City of
Peterborough

SUBJECT: Report PLPD10-040
Application for Site Plan Approval
1002 Chemong Road
4,096 Square Metre Building Addition to Walmart

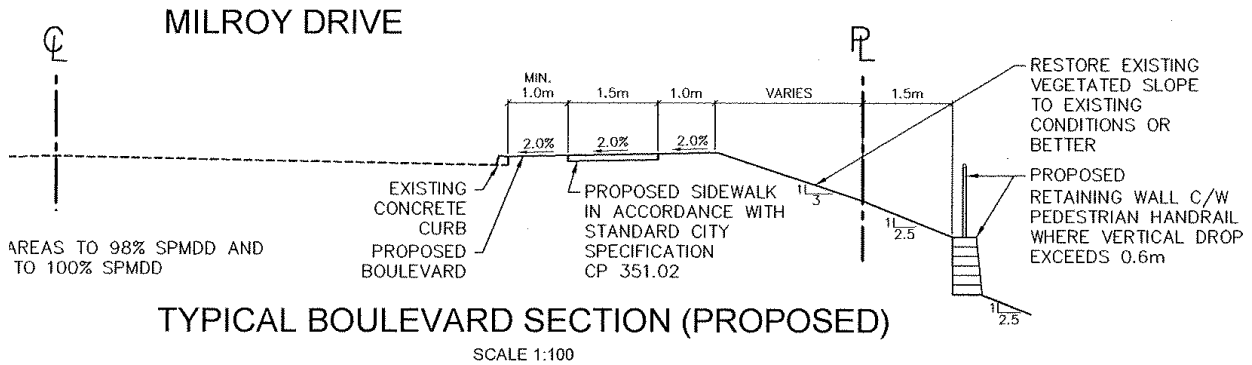
City Engineering staff have reviewed the grading situation along Milroy Drive, and have concluded that Walmart is responsible for raising the grades along the property line, so that an acceptable grade on the boulevard can be achieved. This will result in the construction of an additional retaining wall, between the existing wall and the property line along Milroy Drive. The site plan approval associated with the proposed building addition includes the raising of grades in the Milroy Drive boulevard all at Walmart's full expense.

The proposed solution to the grading of the Milroy Drive boulevard is illustrated below:

A new retaining wall is proposed above the existing wall. At its highest point the retaining wall will be approximately 1.5 metres (5 feet) high. In accordance with the property standards By-law, a black vinyl chain-link fence is to be constructed across the top of the wall for protection. Behind the wall, the grade will slope up, then slope gently back down to the road. A new sidewalk will be constructed at the developer’s expense across the entire frontage of the subject property on Milroy Drive. The standard sidewalk is proposed to be set back 1.0 metres from the curb, and 1.0 metres from the point on the boulevard where the grade slopes down toward the new retaining wall. The proposed solution has been reviewed and is recommended for approval by the Director of the Utility Services Department.
